# UNITED STATES PATENT AND TRADEMARK OFFICE

APPLICATION NO.	FILING DATE	FIRST NAMED INVENTOR	ATTORNEY DOCKET NO.	CONFIRMATION NO.
10/780,082	02/17/2004	Michael L. O'Banion	0275Y-625COD	9514
27572	7590	01/25/2005	EXAMINER	
HARNESS, DICKEY & PIERCE, P.L.C. P.O. BOX 828 BLOOMFIELD HILLS, MI 48303			MITCHELL, KATHERINE W	
			ART UNIT	PAPER NUMBER
			3677

<b>Office Action Summary</b>	<b>Application No.</b>	<b>Applicant(s)</b>
	10/780,082	O'BANION ET AL.
	<b>Examiner</b>	<b>Art Unit</b>
	Katherine W. Mitchell	3677

## DETAILED ACTION

Top plan view of  
fastener

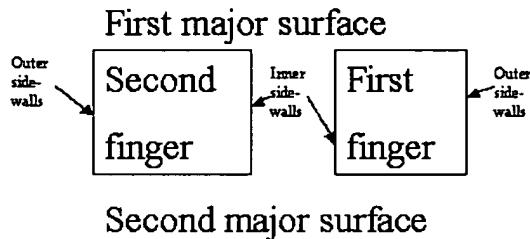
3. Examiner is assuming, based on an interview with attorney in related case 10/780072, that the major surfaces and sidewalls are arranged as below:

4. Fig 4 should be described as a front view, not a side view, if Fig 3 is a side view.

Examiner assumed teeth not labeled are teeth 40.

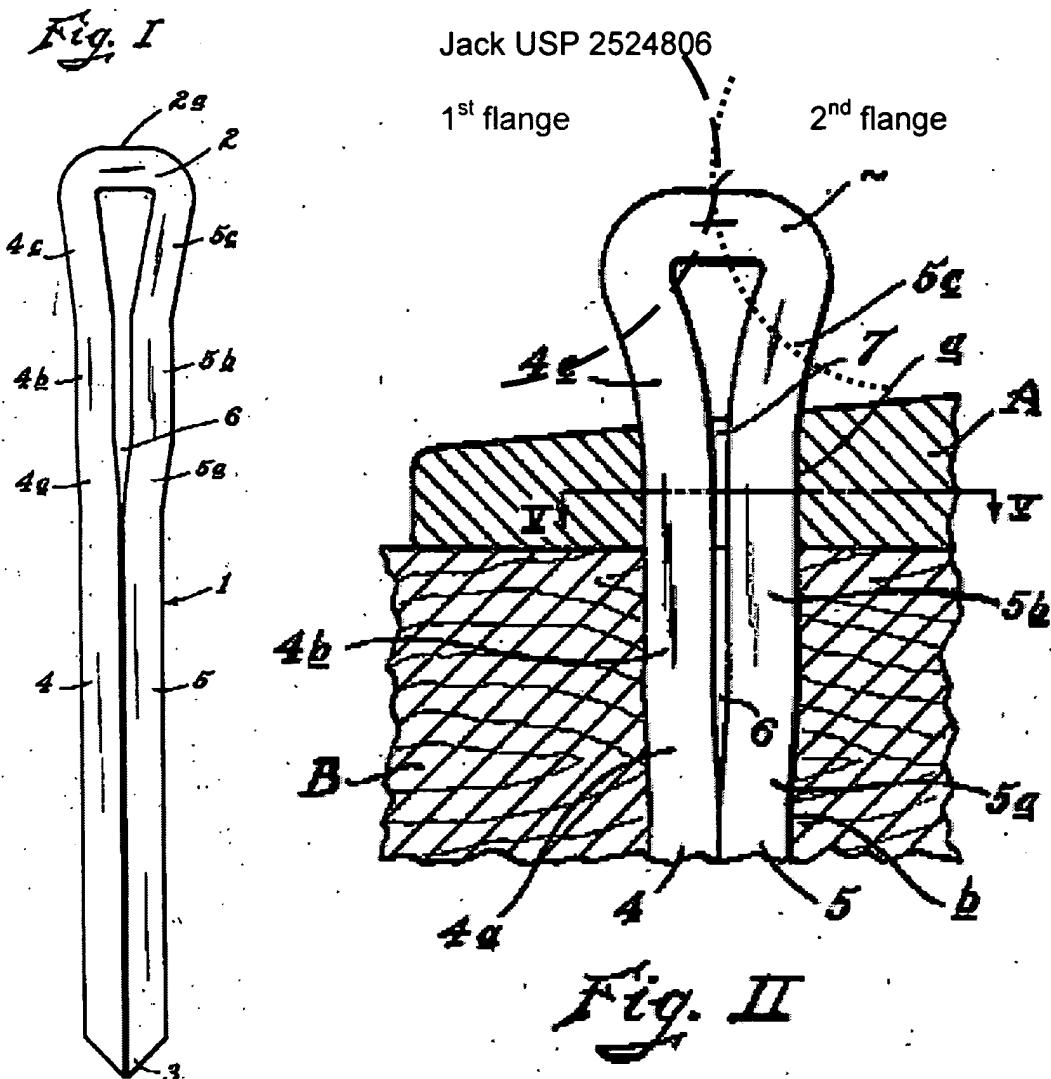
Re claims 85 and 104: Jack teaches in Figs I and II a nail capable of fastening framing members together comprising:

- First member (4) having elongated section (at 4 in Fig I), a flange segment (Shown in Fig II as marked up by examiner above as the section included by the **dashed** arc, red in electronic version, please assume a more vertical split of “2”), and an angular segment 4a, 4b not parallel to elongate and flange segments ; and
- Second member (5) having elongated section (at 5 in Fig I), a flange segment (Shown in Fig II as marked up by examiner above as the section included by the **dotted** arc, blue in electronic version), and an angular segment 5a,5b not parallel to elongate and flange segments ; and

- Wherein said elongated segments are substantially parallel to one another and form a tip (3) configured to penetrate adjacent framing members (A,B, Fig II), said 1<sup>st</sup> and 2<sup>nd</sup> members configured to receive a driving force that drives a portion of said 1<sup>st</sup> and 2<sup>nd</sup> members through said framing members (col 3 lines 50-64) said driving capable of causing said angular segments to move toward one another and said elongated

segments to move away from each other (col 4 lines 39-72), thereby fastening said framing members together between said elongated and flange segments (Fig II).
